Product Change Notification / BLAS-06MZPU737

CCB 6263.001 Final Notice: Qualification of MMT as an additional final test site for SY58031UMG-TR catalog part number (CPN) available in 32L VQFN (5x5x0.9mm) package.

CCB 6263.001
Pre and Post Change Summary
PCN#: BLAS-06MZPU737

Tape and Reel – BQM and Pin1 Orientation (5x5x0.9mm)

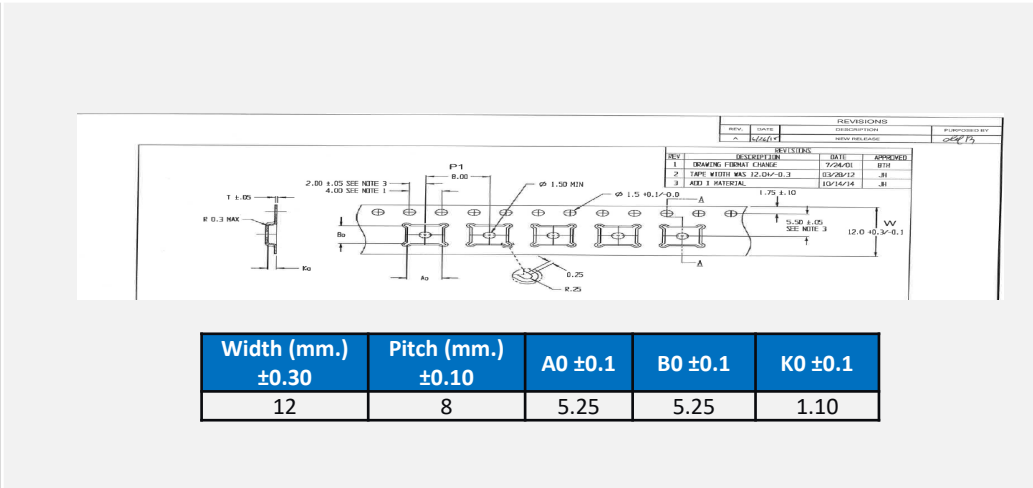
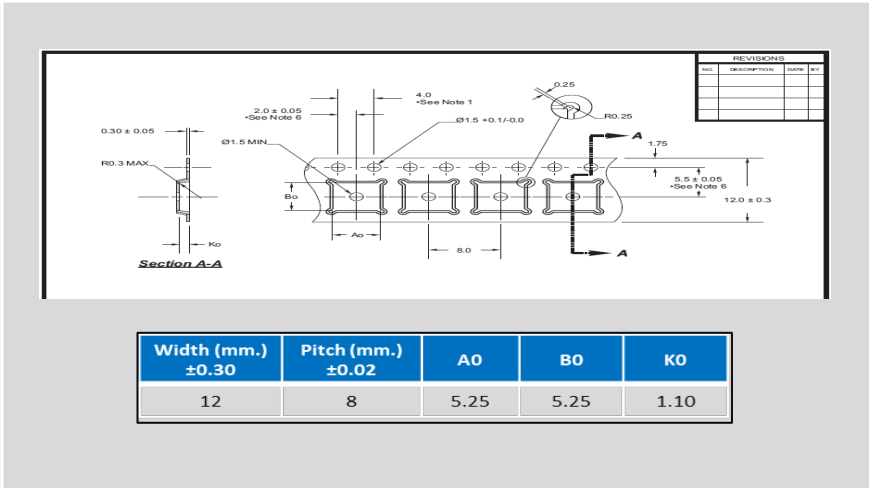
UNISEM	MMT
Base Quantity Multiple (BQM)	1000 per reel	1000 per reel
Pin1 Orientation	 <div>Pin 1 Orientation in T/R</div> <div>Quadrant 1</div>	 <div>Pin 1 Orientation in T/R</div> <div>Quadrant 1</div>
Desiccant and HIC	 <div>Microchip Standard Barcode Label</div> <div>2 X 1 Unit Desiccants</div> <div>HIC</div>	 <div>Desiccant</div> <div>HIC 3 dots</div>

Tape and Reel – Cover Tape (5x5x0.9mm)

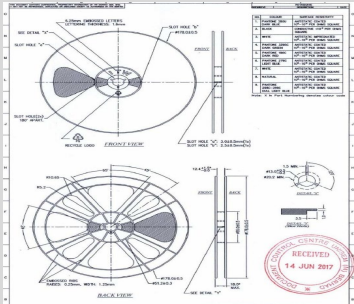
Cover Tape Width (mm.)	Cover Tape Thickness (mm.)	Color
9.2 ±0.1	0.056 ±0.005	Pale Blue

Cover Tape Width (mm.)	Cover Tape Thickness (mm.)	Color
9.05 +0.05/-0.15	0.050 +/-0.010	Clear

Tape and Reel – Plastic Reel (5x5x0.9mm)

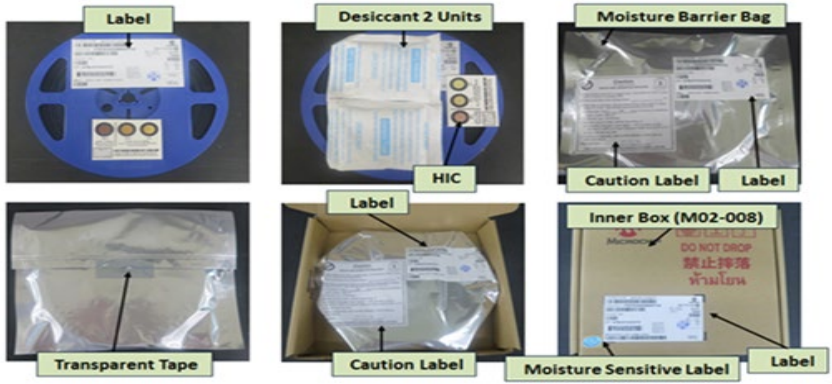
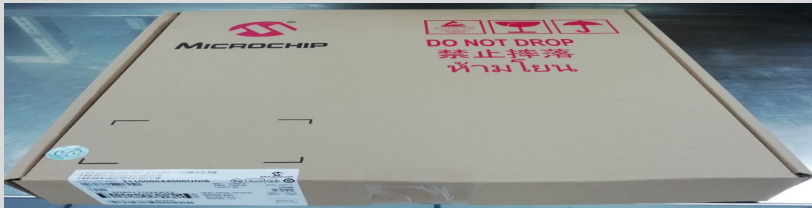
Diameter (mm.)	Hub (mm.)	Width (mm.)	Color
178± 0.5	55± 0.5	12.4+1.5	Light Blue

Diameter (mm.)	Hub (mm.)	W Max (mm.)	Color
178±2.0	60.5±0.5	18.40	Dark Blue
